**Agenda Title:** DISCUSSION REGARDING WASTEWATER TREATMENT PLANT INFLUENT METERING SYSTEM EVALUATION

**Subject: Parshall Flume Design Memorandum**

SUBJECT: Review of City of Willits Wastewater Treatment Plant Influent Flow Meter  
B&R File No. 3478.00

**Figure with Parshall Flume Dimensions (specified and field measured)**

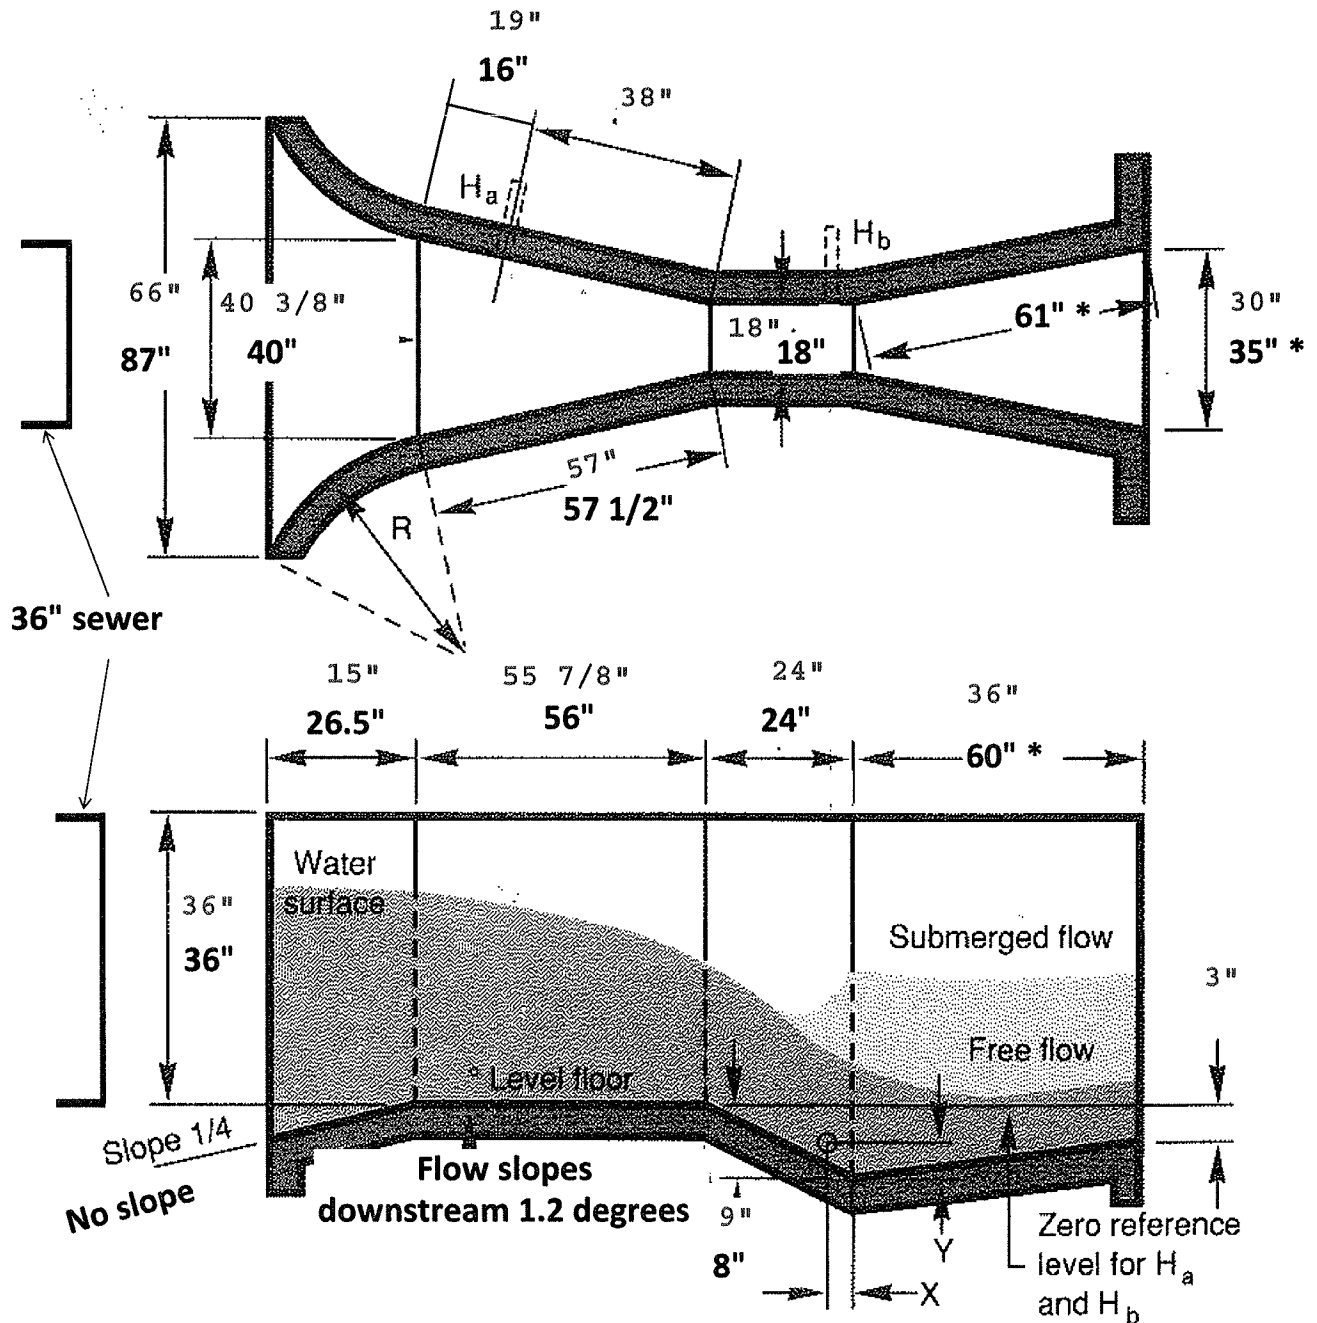
The dimensions of the flume were measured in the field, to the extent possible, and compared with the dimensions specified by the flume design. A figure with the comparative dimensions is attached as Exhibit C. Photographs of the flume installation are included in Exhibit D. The flume was constructed using a preformed fiberglass form, which ensured that the basic dimensions are correct. As can be seen in the photographs, the throat and downstream sections of the flume and channel are covered by grating. Dried wastes on the top of the grating and adjoining floor give evidence that sewage has backed up into the vault in the past. The frequency of such events is not known. B&R was not able to lift the grates to measure and observe the downstream portions of the flume and channel.

**Photographs**

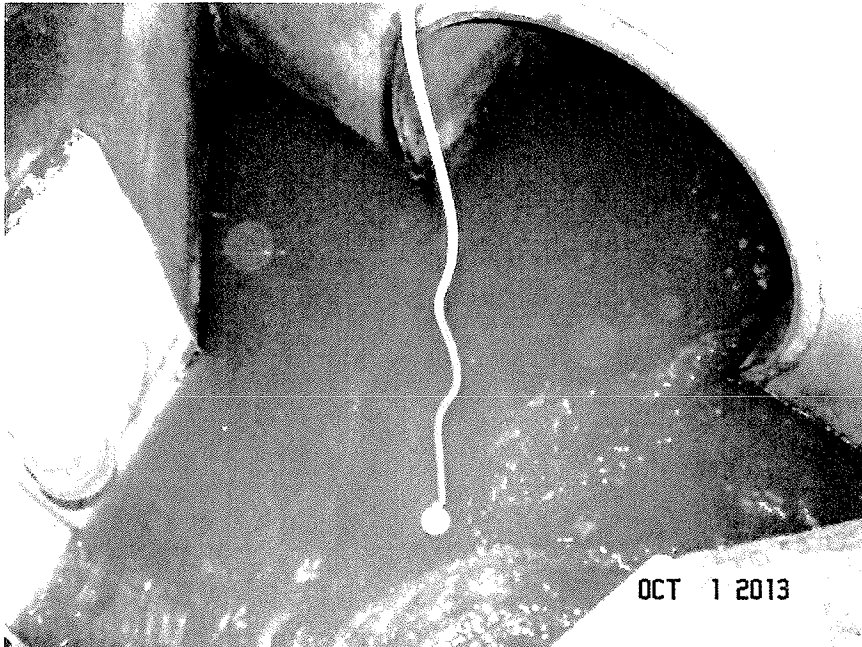
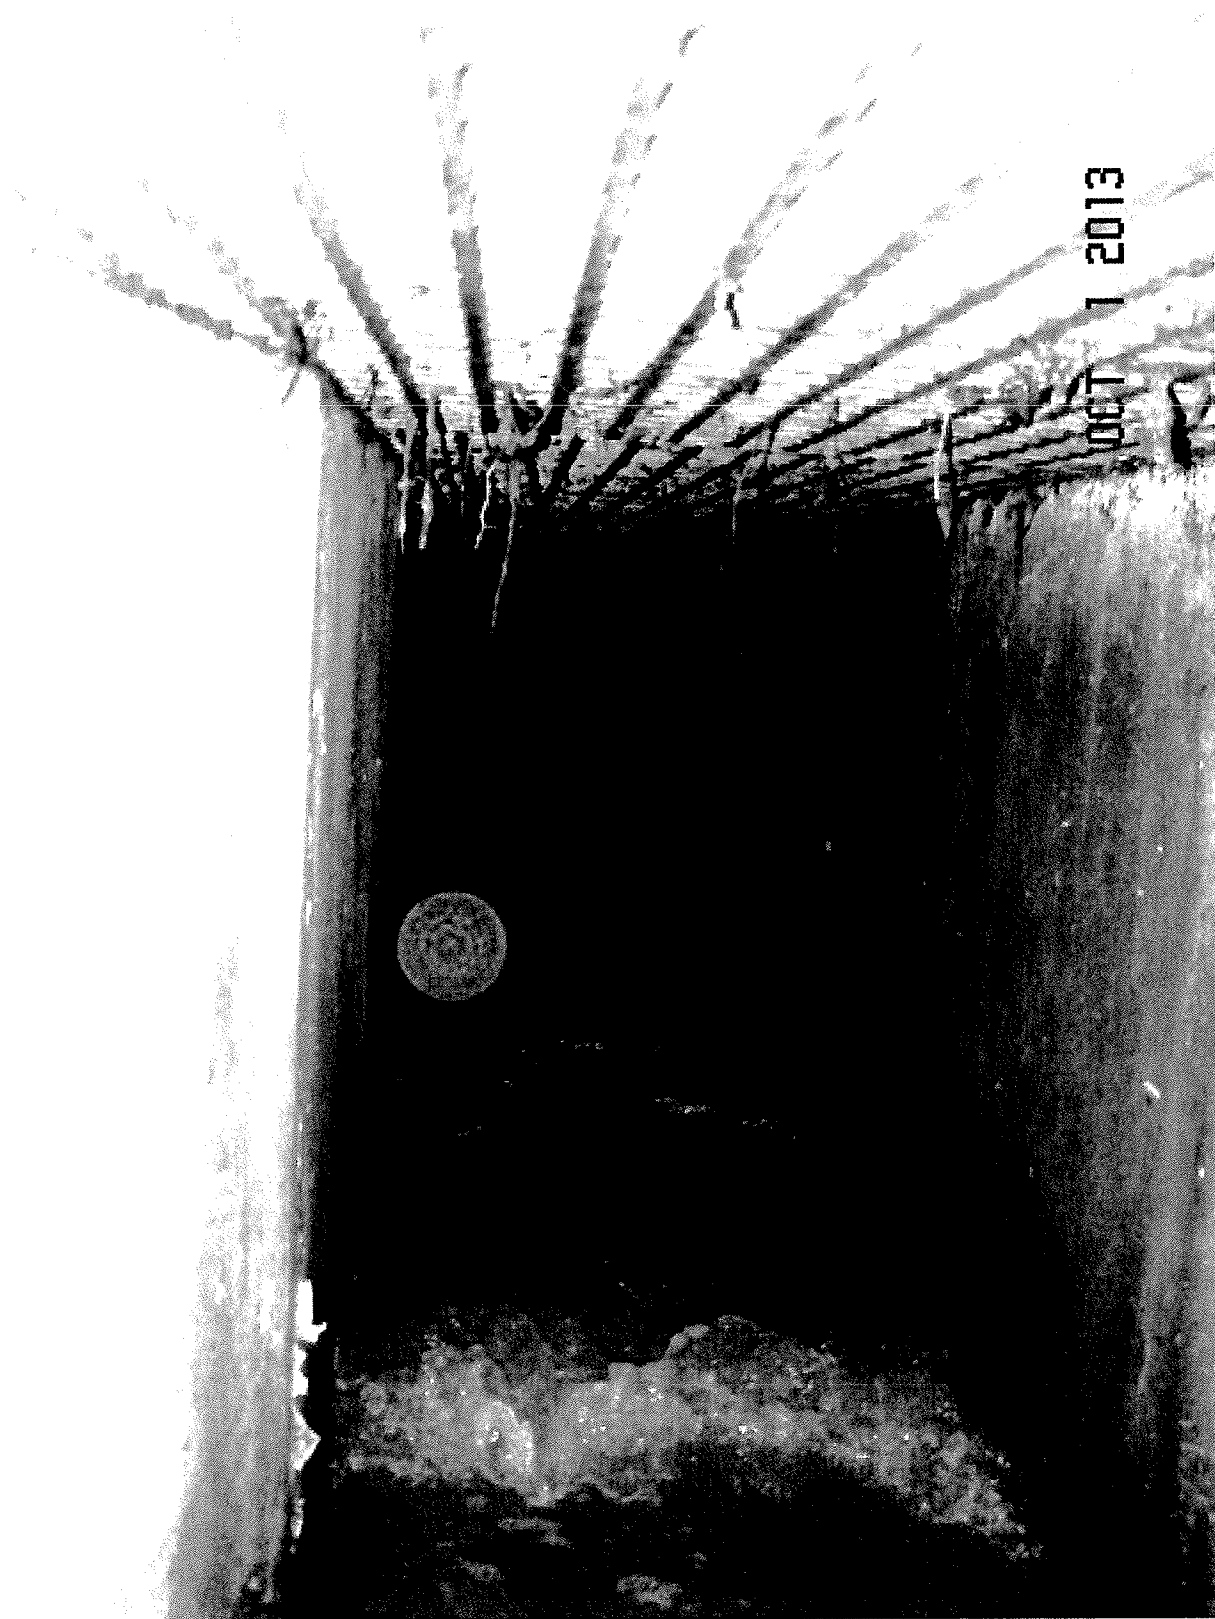
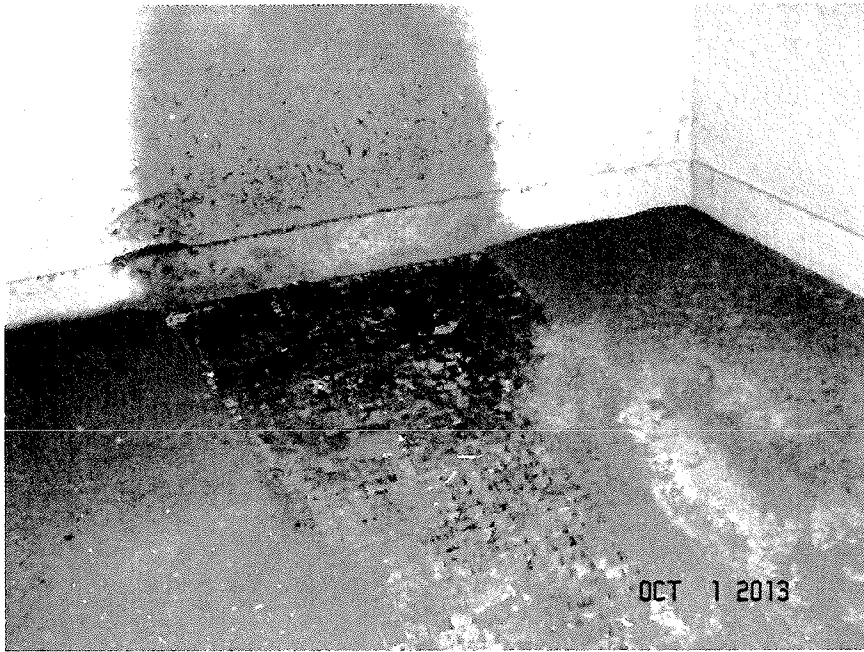
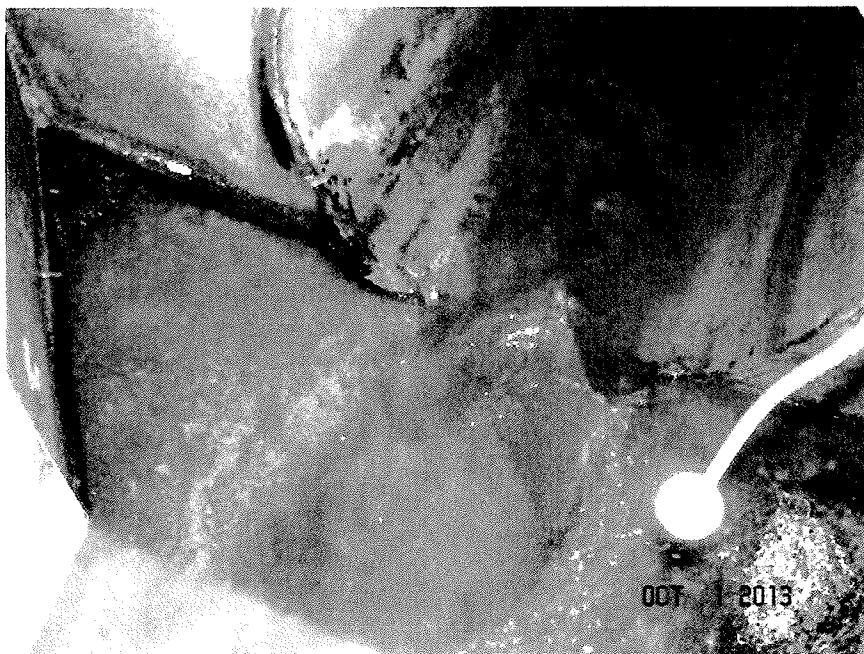
1. The side walls of the channel flare out between the incoming sewer and the beginning of the flume structure. Observations indicate that eddying occurs in the side coves produced by this configuration, and water entering the flume was observed to mound. The City's as-built record plan shows the walls making a direct, smooth transition from the edge of the sewer to the flume. There may be reasons, which we are unaware of, for installation to have been built as it is, but our conclusion is that the transition walls shown on the plans would have produced less irregularities in the water surface.
